# CLERMONT COUNTY OHIO

## PLANNING COMMISSION STAFF REPORT

### LAKEFIELD PLACE SECTION 2 BLOCK "C" – REVISED DESIGN PLAN

## Re: Lakefield Place Section 3 Block "C" – Revised Design Plan Review

LAKEFIELD PLACE  
SECTION 2, BLOCK C  
ATTACHED UNIT AREA

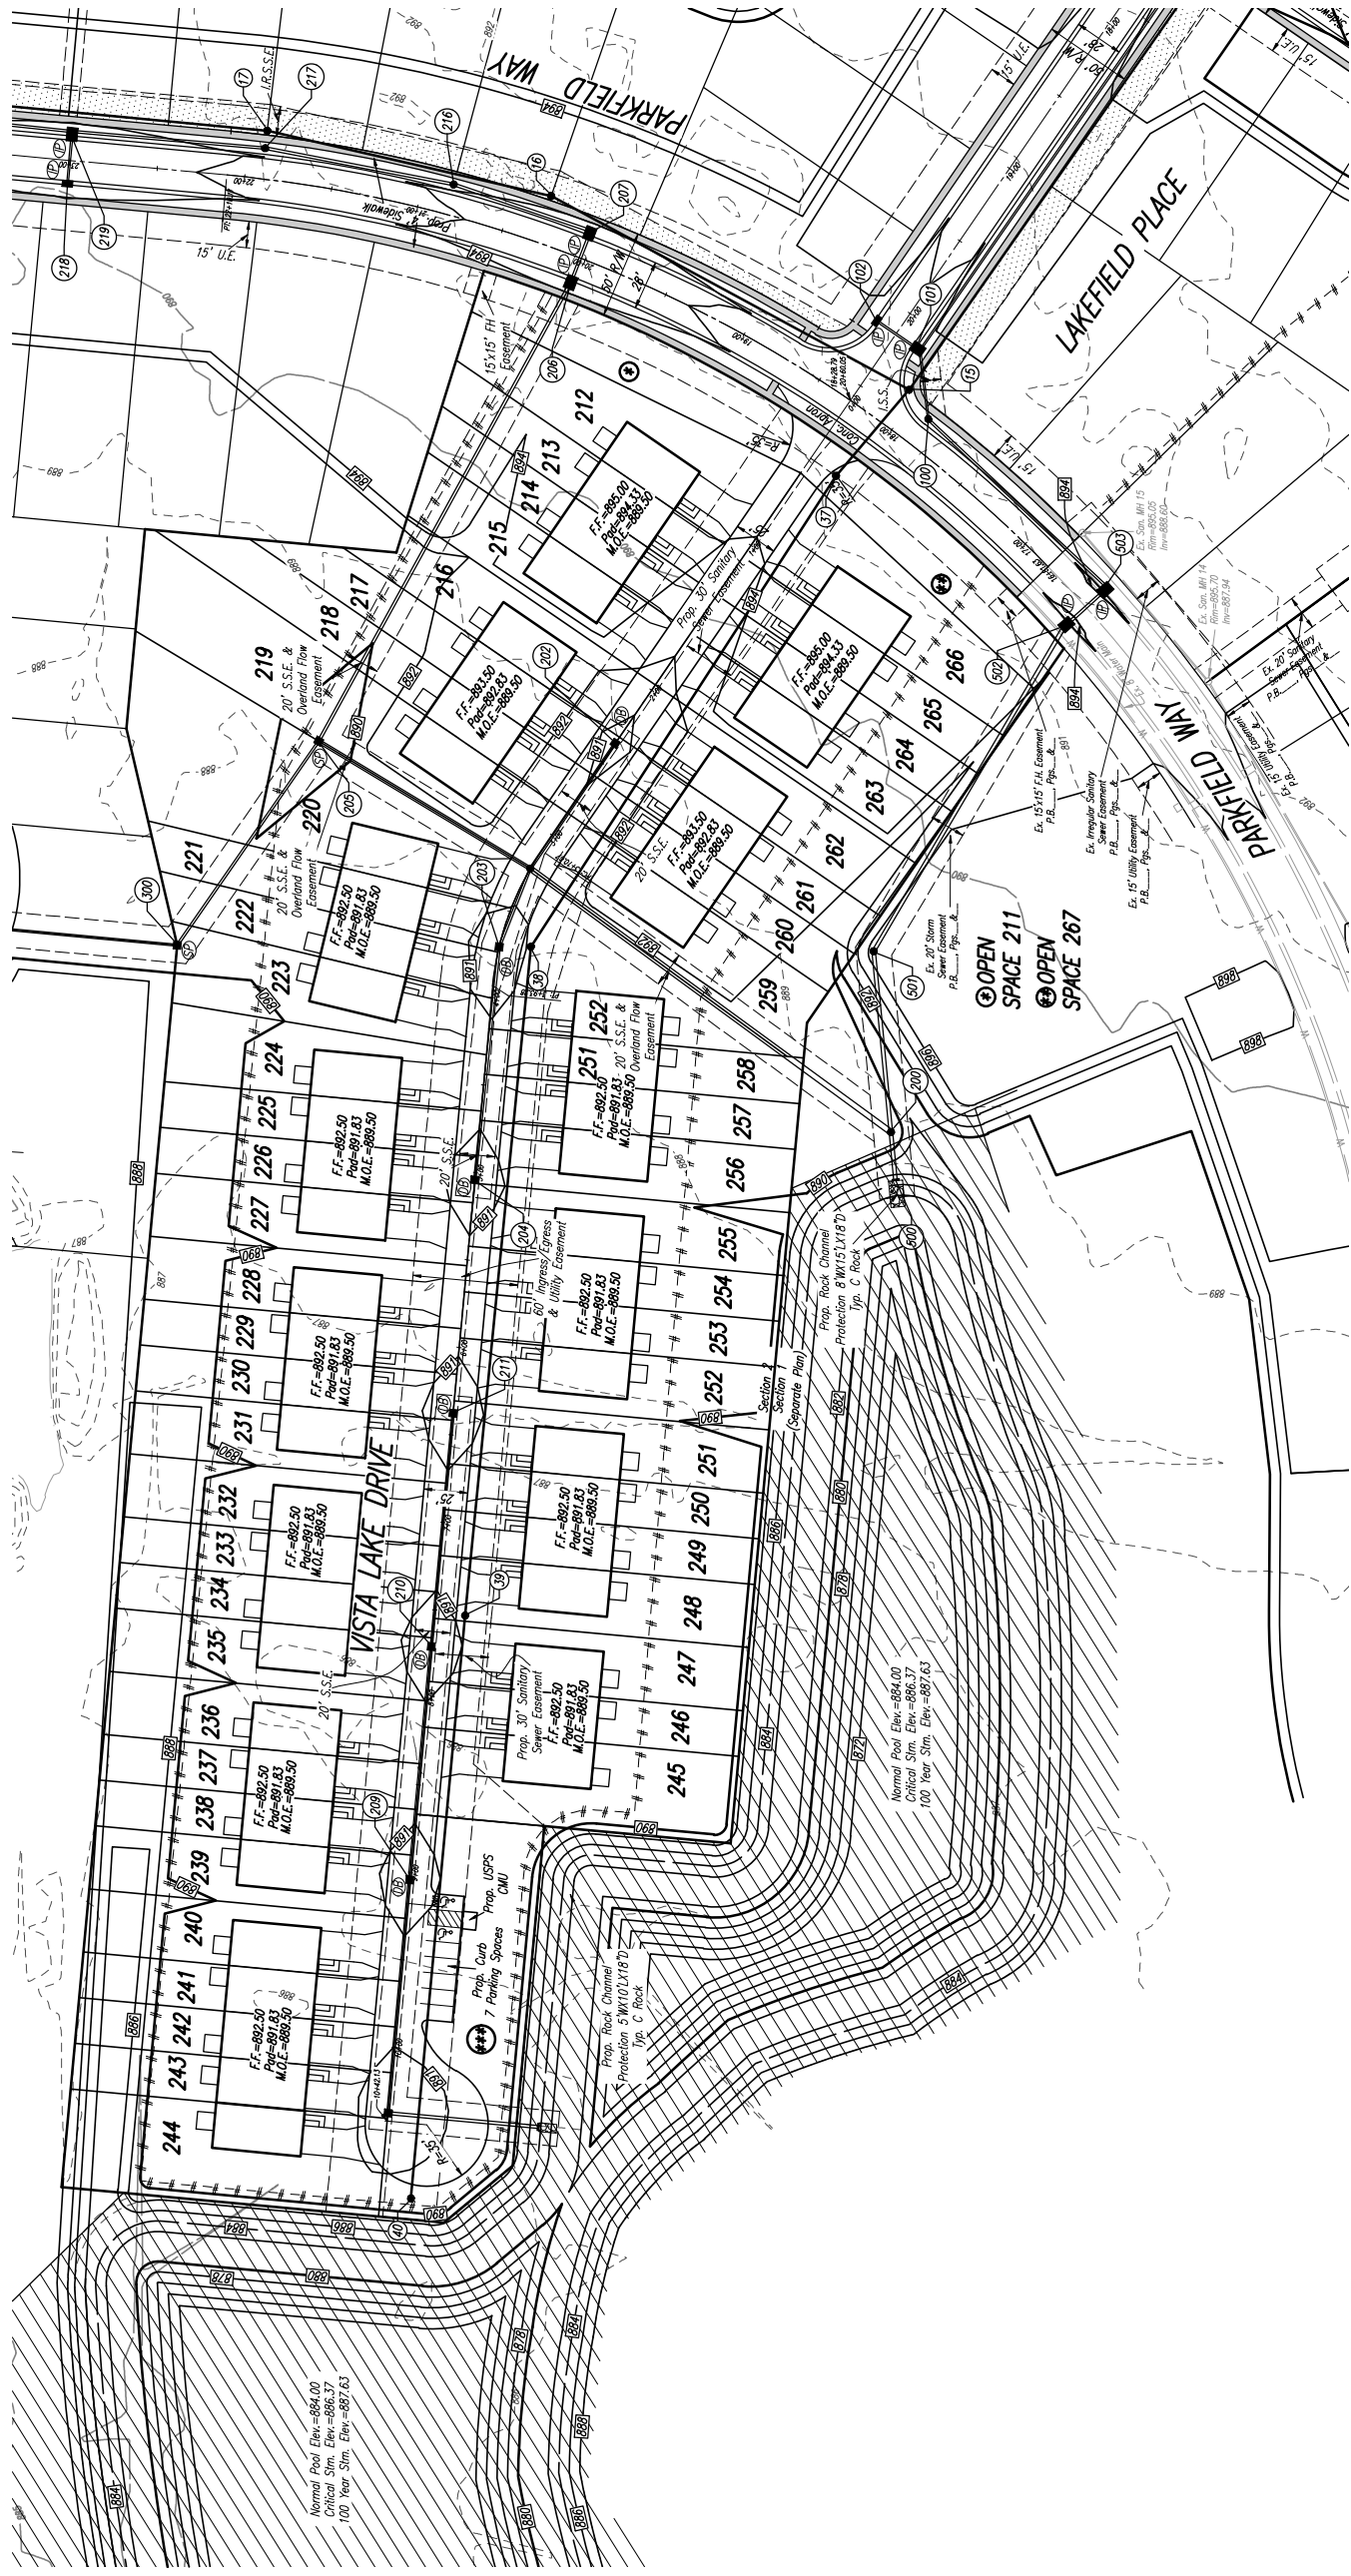
1. The open space behind the structures north of Vista Lake Drive. This is a very flat slope, does additional CB's need to be installed to keep water from ponding in this area?
2. Pg. 6 Proper CB3 #208... diagram has no labels.
